**Final
2015 Five-Year Review Report
for
Rocky Mountain Arsenal
Commerce City
Adams County, Colorado**

Review Period: April 1, 2010 - March 31, 2015

**Revision 0
September 26, 2016**

Navarro Research and Engineering, Inc.

Figure 6.3.1.4-4 Basin A Neck Downgradient Performance Wells – DITH

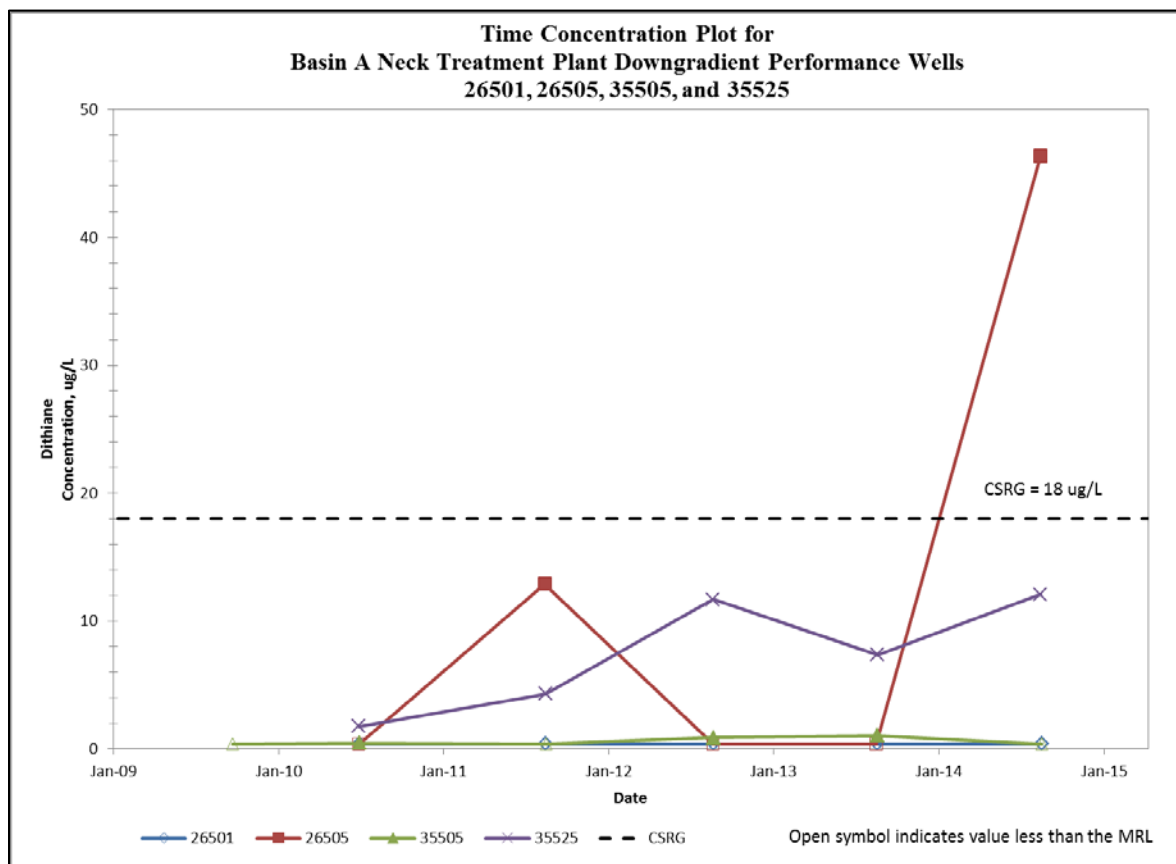
21. **Comment:** The FYRR’s Figure 6.3.1.4-4 “Basin A Neck Downgradient Performance Wells” includes a graph of dithiane. The SSAB requests an explanation of dithiane exceedances in the FYRR.

**Figure 2 Groundwater flow system in hummocky terrain (after Freeze, 1972).**

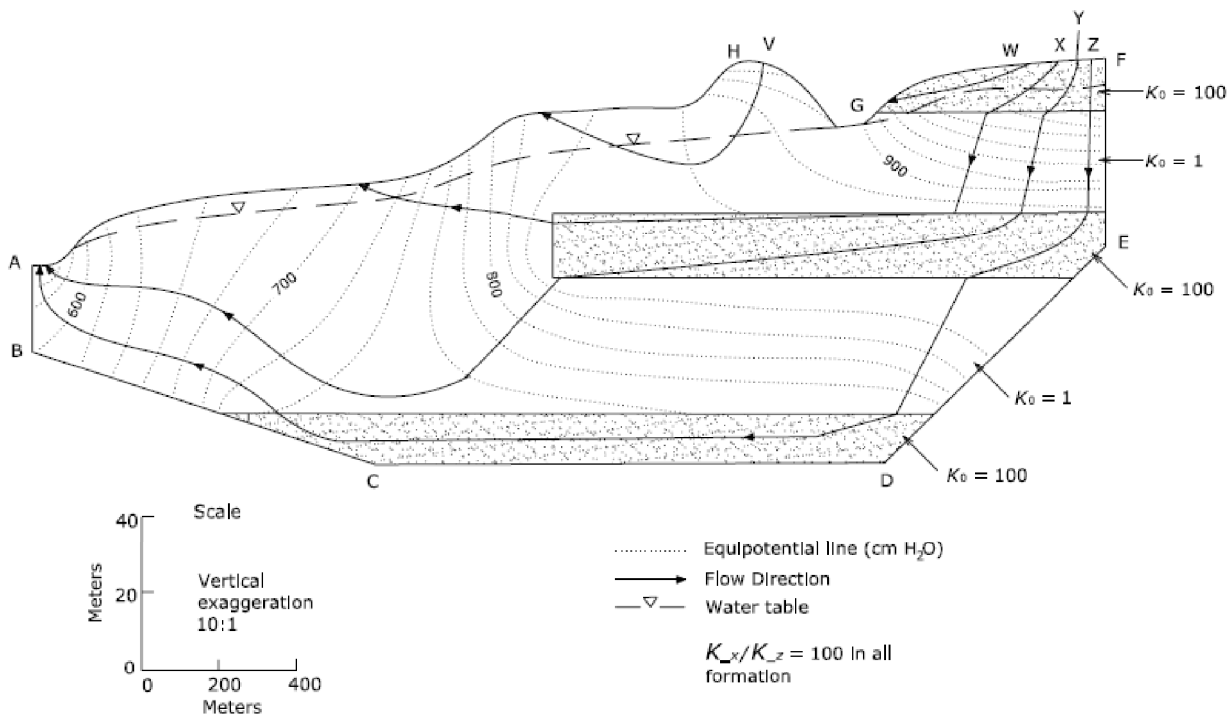
Figure 2 shows a typical groundwater flow system in hummocky terrain, similar to the RMA. The recharge areas are identifiable by the decrease in head with depth and occupy the topographic high ground; groundwater flow in these areas is vertically downward. Most land surface in any flow system is part of the recharge area. The discharge area is confined to the topographic low areas where the hydraulic heads increase with depth. Such groundwater flow patterns are well recognized in the hydrogeological literature; Toth (2010) has recently presented a very substantial monograph of gravitationally-driven groundwater flow systems based upon his own work and that of Freeze (Freeze and Cherry, 1979) and several generations of younger hydrogeologists.

The conceptual groundwater flow system discussed in the GEI Report (Figure 2) only shows the direction of groundwater flow and does not include travel time or flow volume components. As discussed in the Army response for the Confined Flow System, a downward hydraulic gradient only indicates the potential for downward migration. The extremely low vertical hydraulic conductivity in the confined Denver Formation would cause any downward migration to be extremely slow with extremely small volumes. As discussed previously, there is no evidence for the bedding plane fractures in the Denver Formation at RMA that the GEI Report indicates may be causing underflow of contaminants. Additionally, there is no evidence that underflow in the Denver Formation is causing off-post migration of contaminants based on water-quality monitoring data. For any conceptual model to be viable, it must be validated by site-specific data. No site-specific data supports the conceptual groundwater flow system discussed in the GEI Report.

**Figure 3 Site Topography**

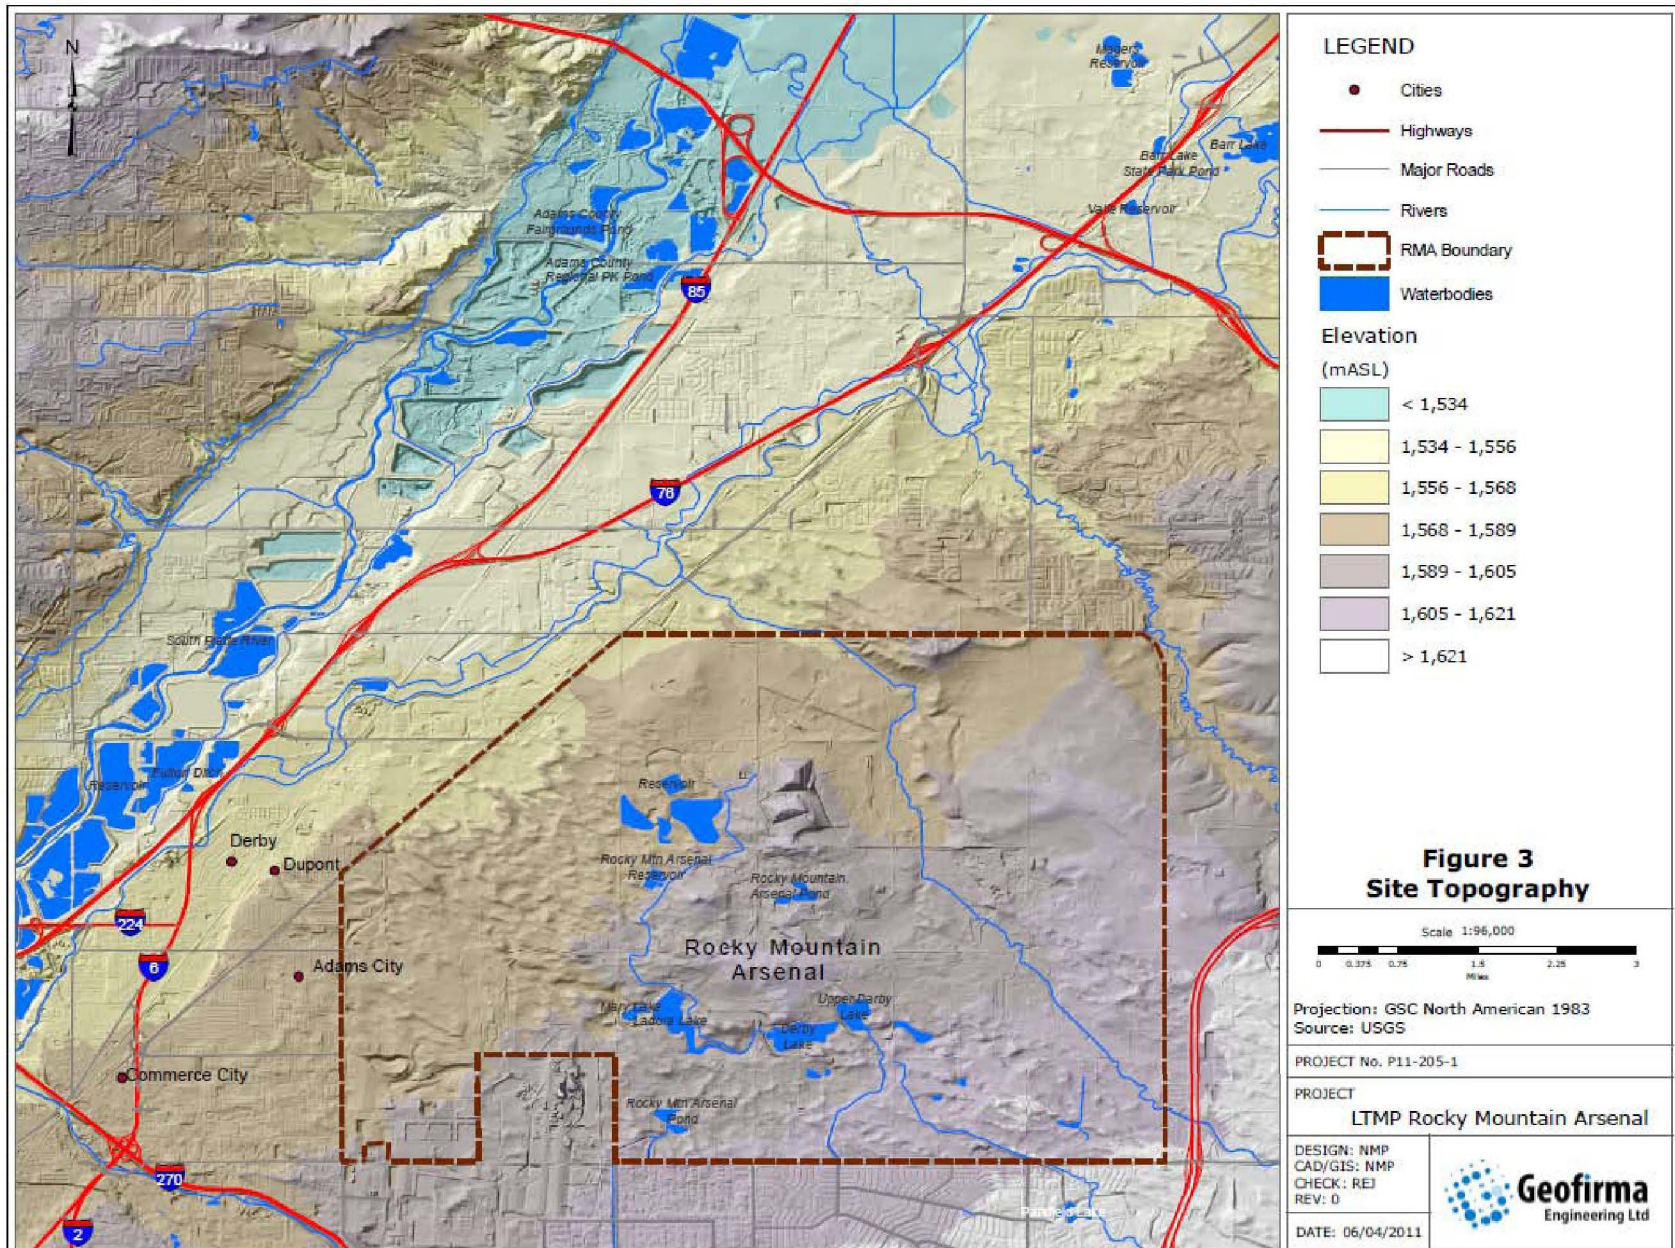
With this background in mind, it is possible to see the whole of the RMA as forming a recharge area of a flow system that discharges in the South Platte Valley. Figure 3 presents a Digital Elevation Model produced from US Geological Survey data showing the topography that governs the RMA flow system. Table 6.1-7 of the Plan lists hydraulic head data and hydraulic gradient directions for monitoring wells that indicate downward flow and referred to in section 6.1.3.1 as “*adjacent wells*”. This data is therefore consistent with our conceptual model of the RMA flow system in which the RMA is a recharge area. Even in the far NW corner of the RMA, i.e., Section 23, there is a downward gradient between the unconfined and the confined Denver Formation (fm.), i.e.,  $dh/dL = 0.93$  in well pair 23185-23187 and  $= 0.99$  in well pair 23191-23193. A vertical hydraulic gradient approaching unity is to be expected in a continuously saturated flow system (Hart et al., 2008), in this case the Denver fm. Such a large gradient can be expected to produce a deep flow pattern with streamlines traveling to considerable depths. It is on the basis of this flow system that underflow through the Denver fm. may occur must be judged as a distinct possibility.

**Figure 4** Dakota sandstone, Dinosaur Ridge, Colorado, showing bedding-plane fractures

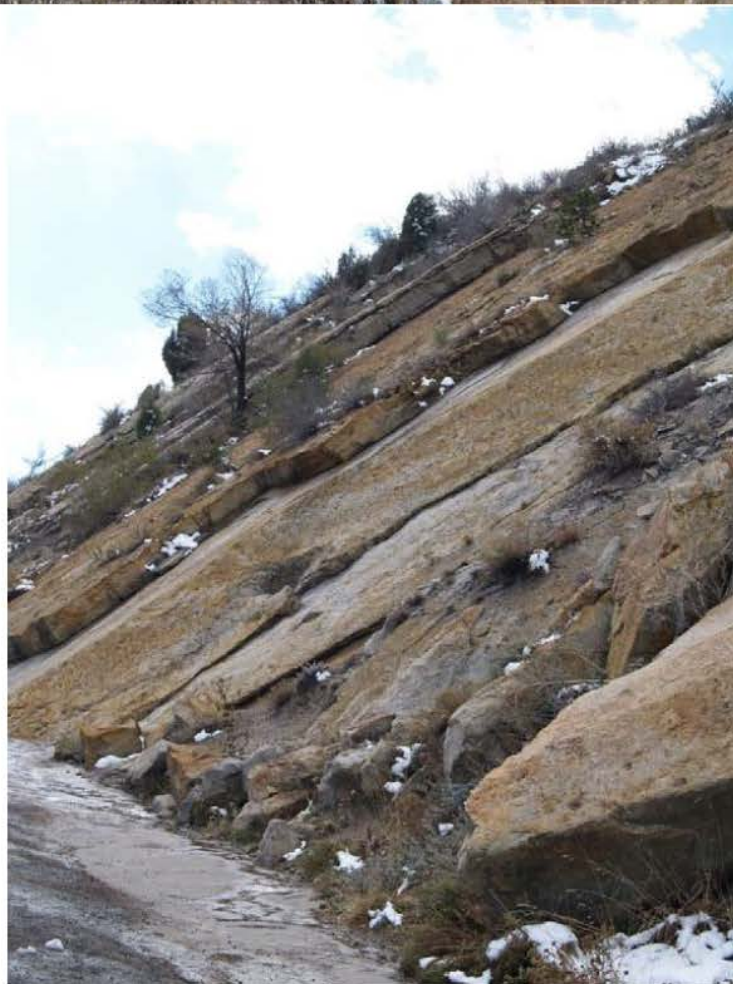
This raises the issue of the nature of groundwater flow in the Confined Flow System (CFS) of the Denver fm, which is shown in outcrop in Figure 4. In fractured sedimentary rocks, flow is mainly through the fractures themselves and the Denver fm is no exception. This conclusion is supported by the effective porosity of 0.001 (0.1%) reported in the tracer test mentioned in Appendix A of the Plan (page 23 of 26), which was presumably conducted in the unconfined Denver fm. Such low effective porosities are exactly what should be expected from tracer tests in fractured sedimentary bedrock (e.g., Freeze and Cherry, 1979, pp. 408-409, Robinson, 1995; Lapcevic et al., 1999; Meigs and

The highly indurated Dakota sandstone shown in Figure 4 in the GEI Report is approximately 8,400 feet deeper than the base of the Denver Formation at RMA (based on the RMA Deep Disposal Well log). The Dakota sandstone would behave as a brittle unit during structural deformation and be more prone to bedding plane fracturing. Additionally, the Dakota sandstone at Dinosaur Ridge, which is also called the Dakota Hogback, is located at the steeply dipping western flank of the Denver Basin, which borders the Colorado Front Range. The dip of the Dakota sandstone in the GEI Report example appears to be 45 degrees or greater. Thus, the Dakota sandstone has undergone significant structural deformation, consistent with the formation of bedding plane fractures. Thus, the Dakota sandstone example in the GEI Report is not relevant to the Denver Formation at RMA.

**Figure 5** Well screens (5ft and 10 ft in length) are used to monitor groundwater conditions across the northern boundary of the RMA. Screens are preferentially located in the sandstone beds; fracture zones are not shown. (Figure 4-6, NBCS Addendum, 2007 Five-Year Summary Report)

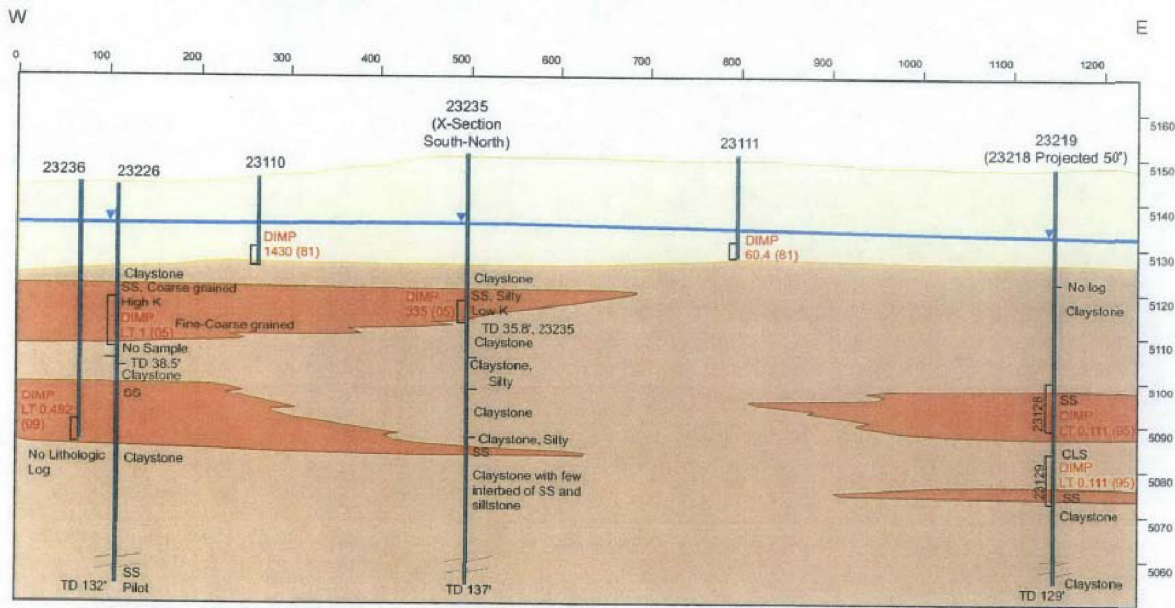
The RMA monitoring wells in the confined flow system of the Denver fm are long screened wells, i.e.,  $\geq 5$  ft screen lengths, that will result in dilution of contamination due to mixing of zones of contaminated and uncontaminated groundwater. It also appears that well screens were preferentially set across the sandstone layers rather than being distributed across bedding planes (see Figure 5) throughout the well for example, (see Figures 4-3, 4-6 and 4-9 in the NBCS Addendum to the 2007 Five-Year Summary Report, Volume 1). This suggests that those responsible for establishing the monitoring well network anticipated that contaminant migration would be by intergranular flow through the sandstones themselves rather than fracture flow along bedding planes. The tracer test cited above argues against this conclusion. Figure 6 shows the distribution of hydraulic conductivity and flow in a sandstone aquifer in Wisconsin and a similar pattern should be expected in the Denver fm.

**Figure 7** Monitoring well network north of RMA (Figure 6.2-1, LTMP). The areas enclosed in boxes are identified as “operational areas” and contain the OGITS extraction wells (unnumbered dots) as well as numbered upgradient and downgradient monitoring wells used to assess performance.

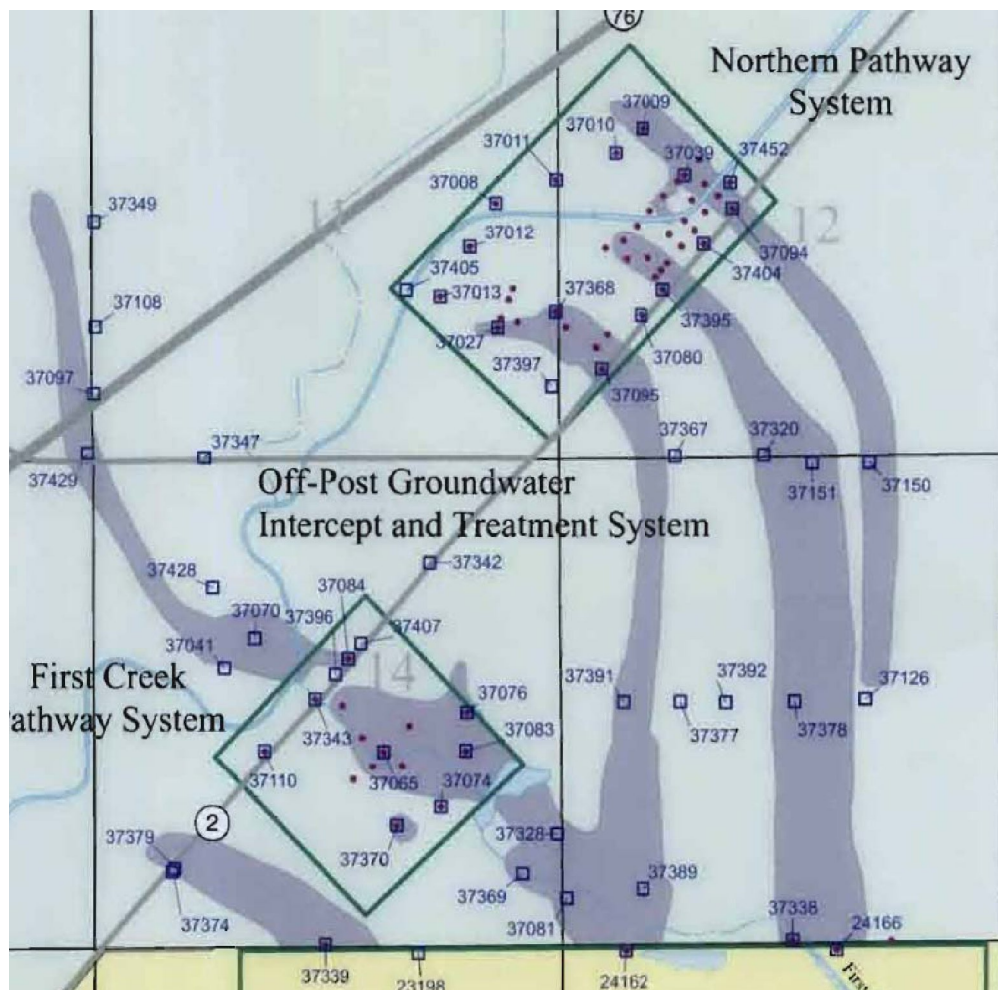
Figure 7 shows a plan view of the OGITS and the Exceedance monitoring-well network. The Plan (TtEC and URS, 2010, p. 21) identifies the following objectives for the OGITS:

Exceedance monitoring is conducted only twice every five years. This is contrary to other Superfund sites where the lowest monitoring frequency is annual. It is recommended that annual sampling and analysis be conducted at all 58 exceedance monitoring wells – i.e., those shown in Figure 7.

**Figure 8** An example of a fence of multi-level monitoring wells that provide a meaningful estimate of contaminant mass flux (from Einarson, 2006)

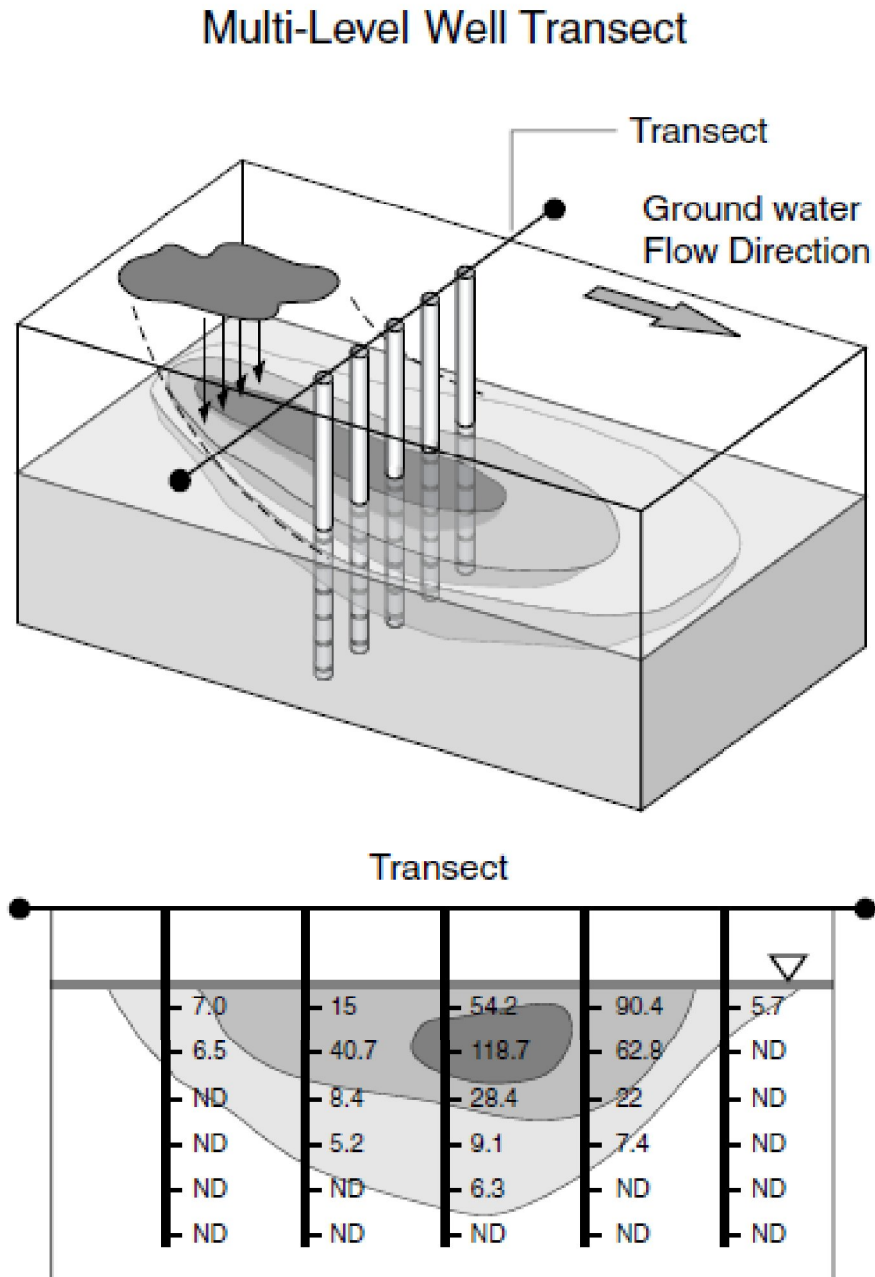
The means for conducting mass flux estimates are now well established in the scientific literature, e.g., Amerson and Johnson (2003), Guilbeault et al. (2005) and Brooks et al. (2008). They are estimated with transects or 'fences' of multilevel monitoring wells not sparsely distributed single-screen wells. Figure 8 shows an example of one such transect that will provide high resolution contaminant data. Furthermore, measurements of contaminant concentrations from extraction wells result in substantial dilution of the contaminant (Jackson and Mariner, 1995) that will affect the accuracy of the mass estimate in comparison with that from a monitoring well that will not be under pumping conditions. Therefore, RMA proposes two different kinds of estimates, one from a pumping well and the other from a non-pumping well, which estimates cannot yield values that are quantitatively comparable. Furthermore, each of these estimates will have very large error bars – so large that the comparison will be meaningless. For these reasons, mass flux estimates of contaminants are now computed by transects of multilevel monitoring wells and compared on that basis.

1. A multilevel transect upgradient of the extraction wells, e.g., a network of at least five (5) multilevel wells along Highway 2 for the Northern Pathway System, one each beside the five exceedance wells shown in Figure 7, and another five (5) upgradient of the First Creek Pathway System;

2. A multilevel transect downgradient of the extraction wells, e.g., a network of at least six (6) multilevel wells, one each beside the six exceedance monitoring wells shown in Figure 7, and another five along Highway 2 downgradient of the First Creek Pathway System;
3. Spatially distributed estimates of contaminant concentration, hydraulic conductivity, hydraulic head and gradient for each zone created by this network of multilevel wells so that a grid can be developed for each transect allowing meaningful Darcy Law estimates of contaminant mass flux.

Multi-level plume-transect monitoring has been conducted at RMA. For example, cone penetration testing (CPT) and multi-level sampling was conducted at selected sites to evaluate plumes in three dimensions similar to that shown in Figure 8 in the GEI Report. Additionally, nested wells have been used at RMA to evaluate vertical plume stratification where the alluvial aquifer is thicker. Where plume stratification was found in a few areas, subsequent wells were screened appropriately or low-flow discrete-depth sampling was conducted to obtain representative groundwater samples.
